SOUTH VALLEY WATER RECLAMATION FACILITY
PROJECT 4D
WEST JORDAN, UTAH

MECHANICAL
BIOREACTOR NO. 4 AIR
DIFFUSER SYSTEM PLAN

SOUTH VALLEY WATER RECLAMATION FACILITY		
WEST JORDAN UTAH		
THIS DRAWING IS THE PROPERTY OF SANITAIRE AND IS SUBMITTED IN CONFIDENCE. IT IS NOT TO BE REPRODUCED, COPIED OR DUPLICATED WITHOUT PERMISSION OF SANITAIRE.		
BIOREACTOR 1-4 STRUCTURAL, DROPLEGS & MANIFOLDS KEY PLAN		
ITT Corporation		
SANITAIRE® BROWN DEER, WISCONSIN 53223 ABJ®		
DRAWN BY: MRL	DATE: 12-4-07	DESIGN: NEW/REV
CHKD BY: MTR	DATE: 12-12-07	STD.
APPROV BY: DE	DATE: 12-13-07	SHEET: 2 OF 40
JOB: 07-67425		
S-2

BIOREACTOR 1-4
AERATION GRIDS
KEY PLAN

OX-2
GRID TYPE 2
PLAN VIEW (6)

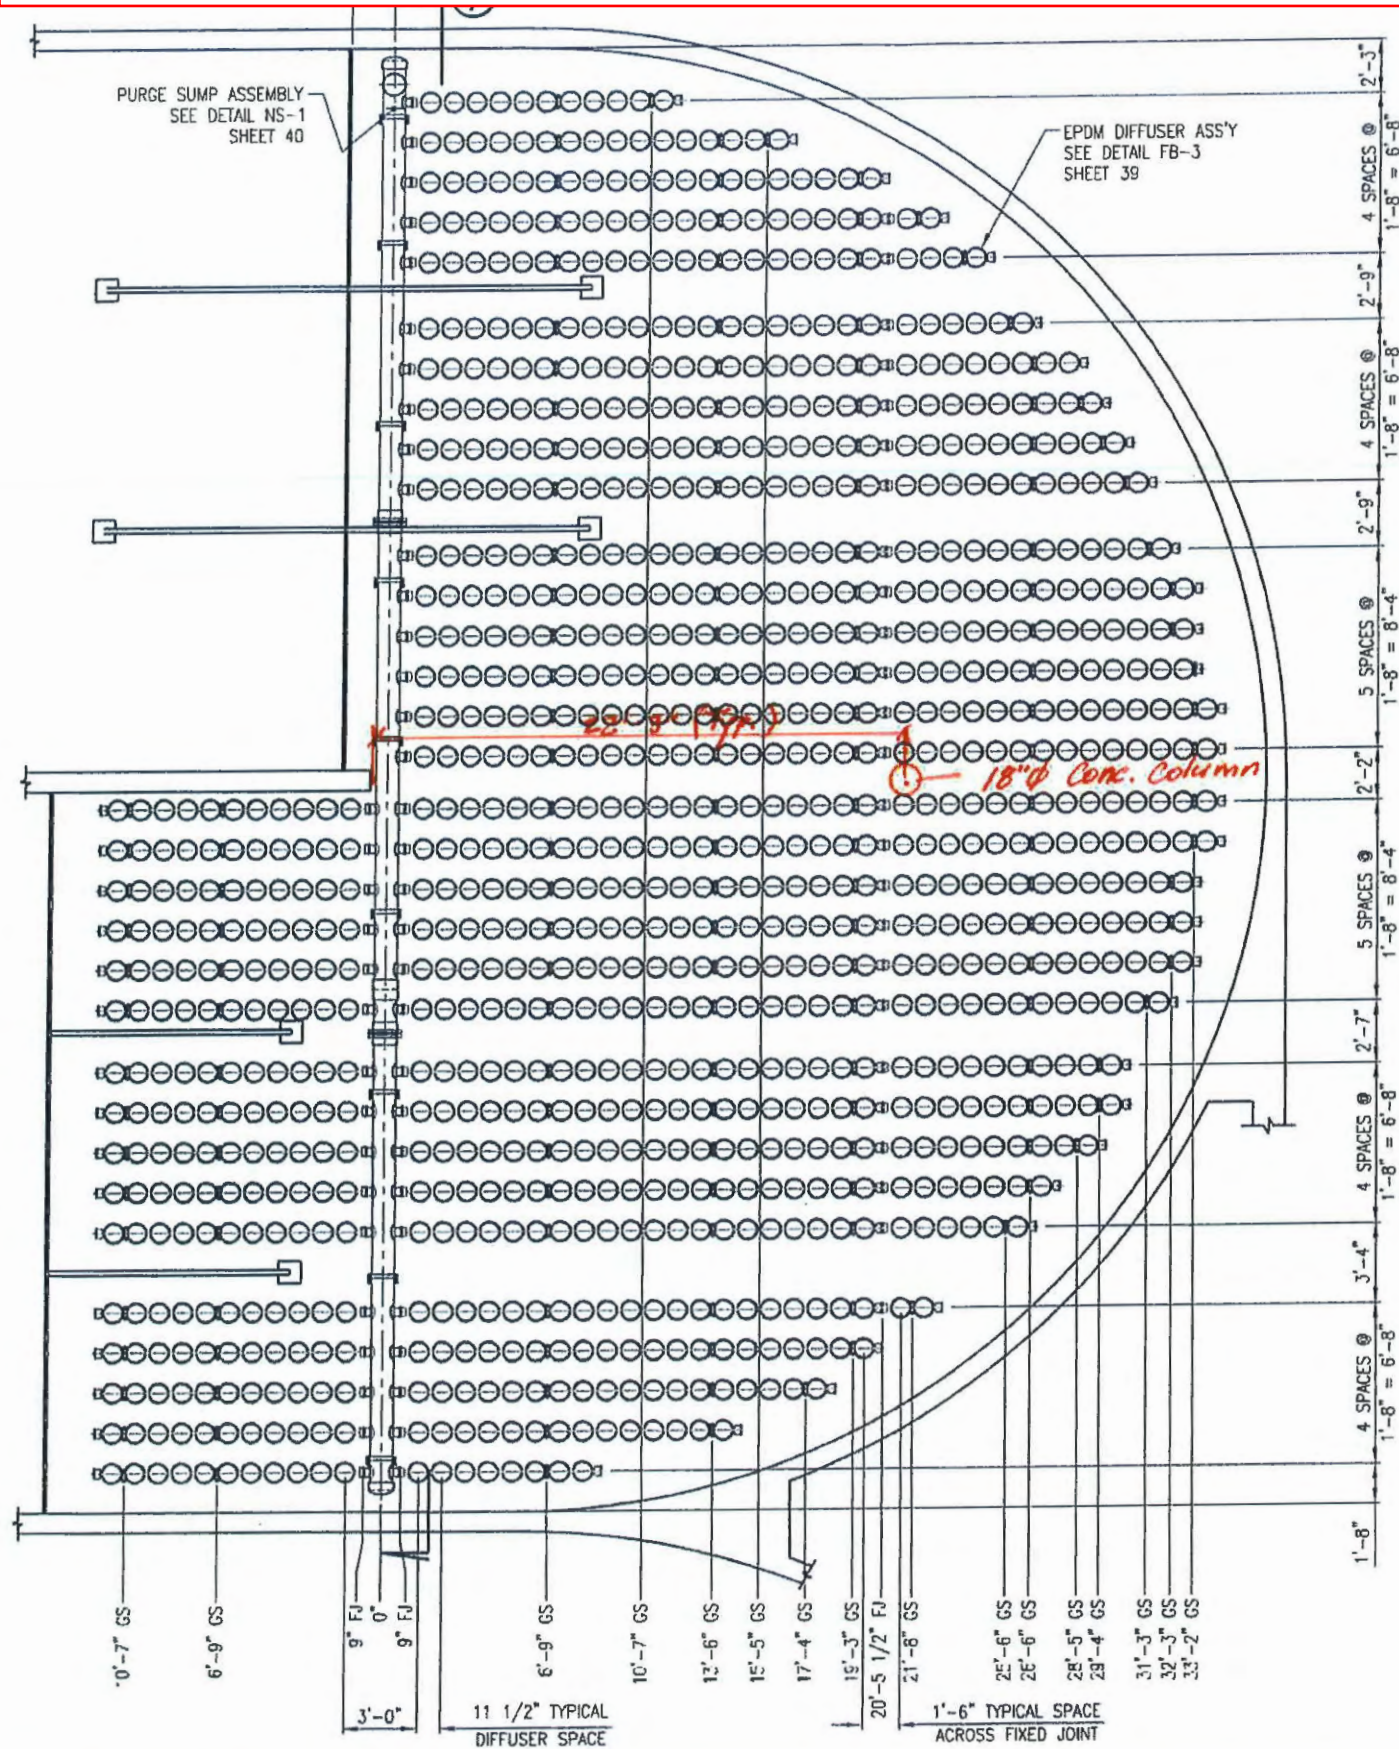
FOR THIS GRID:
REMOVE AND REPLACE ALL EPDM MEMBRANE DIFFUSERS IN BIOREACTOR 2.
REMOVE ALL EPDM MEMBRANE DIFFUSERS, PVC RETAINER RINGS, PVC SUBPLATES IN BIOREACTOR 3.

OX-3
GRID TYPE 3
PLAN VIEW (B)

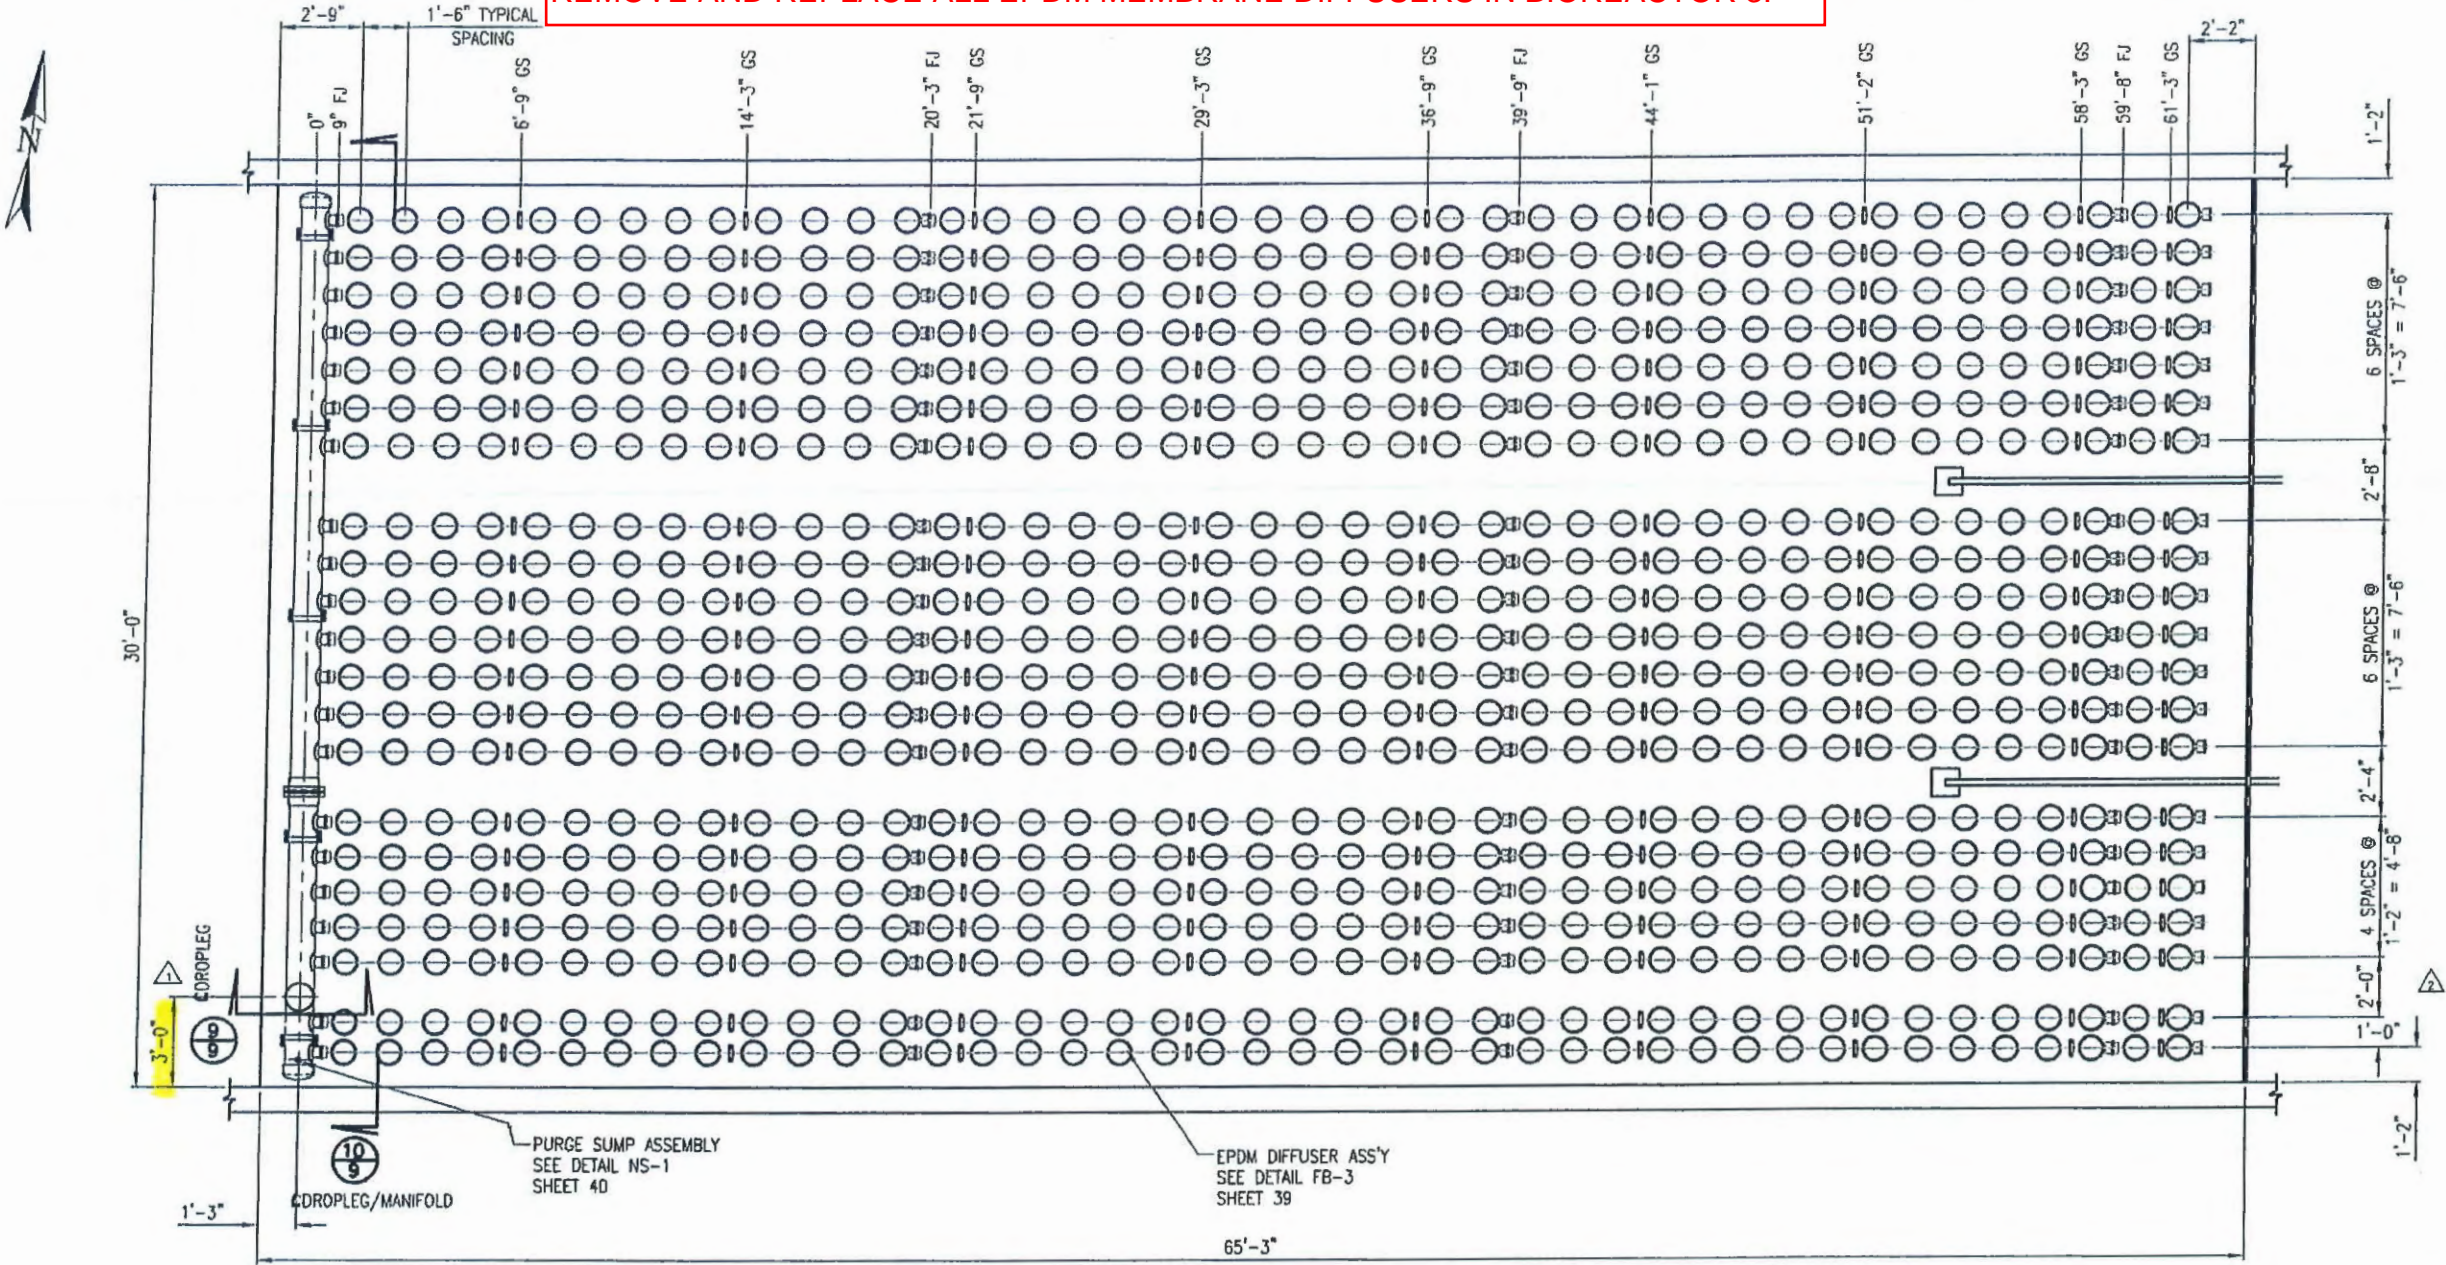
FOR THIS GRID:
REMOVE AND REPLACE ALL EPDM MEMBRANE DIFFUSERS IN BIOREACTOR 2.
REMOVE AND REPLACE ALL EPDM MEMBRANE DIFFUSERS IN BIOREACTOR 3.

OX-4
GRID TYPE 4A
PLAN VIEW 11

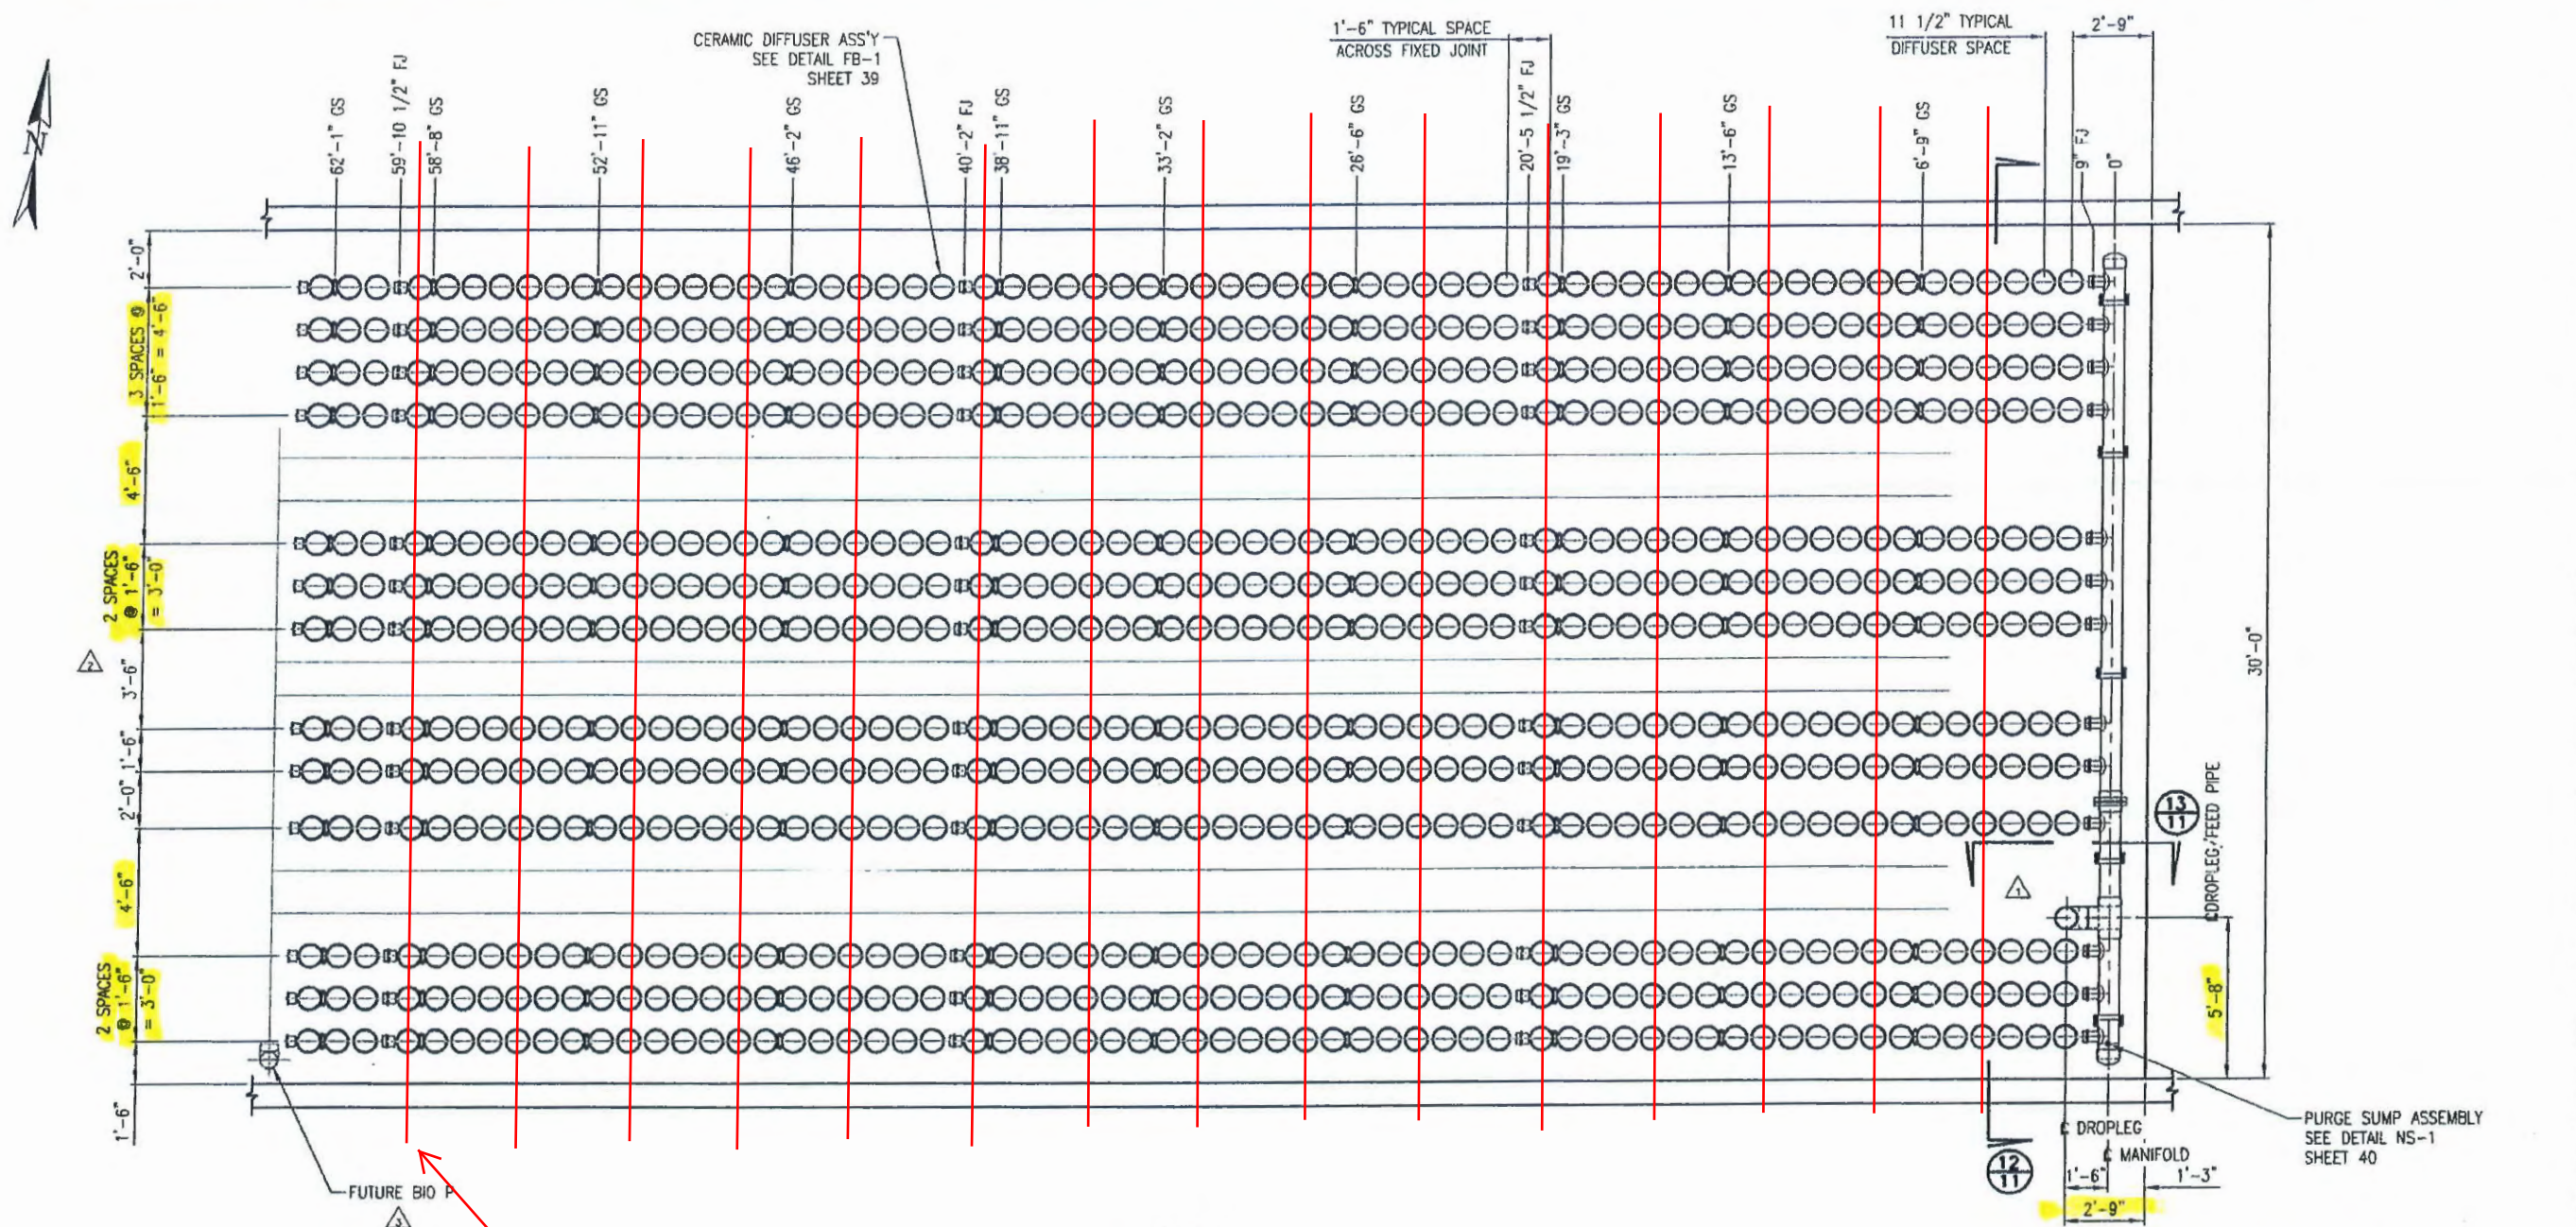
FOR THIS GRID:
1) REMOVE 195 CERAMIC DIFFUSERS AND ASSOCIATED O-RINGS AND PVC RETAINER RINGS. INSTALL NEOPRENE PLUGS IN ORIFICE HOLES AND LEAVE DIFFUSER HOLDERS EMPTY AS INDICATED BY RED LINES. FINAL EPDM MEMBRANE DIFFUSER COUNT IN THIS GRID IS 624. TYPICAL BOTH BIOREACTORS.
2) PROVIDE AND INSTALL EPDM MEMBRANE DIFFUSERS WITH PVC SUBPLATES TO REPLACE ALL OTHER EXIST CERAMIC DIFFUSERS. TYPICAL BOTH BIOREACTORS.
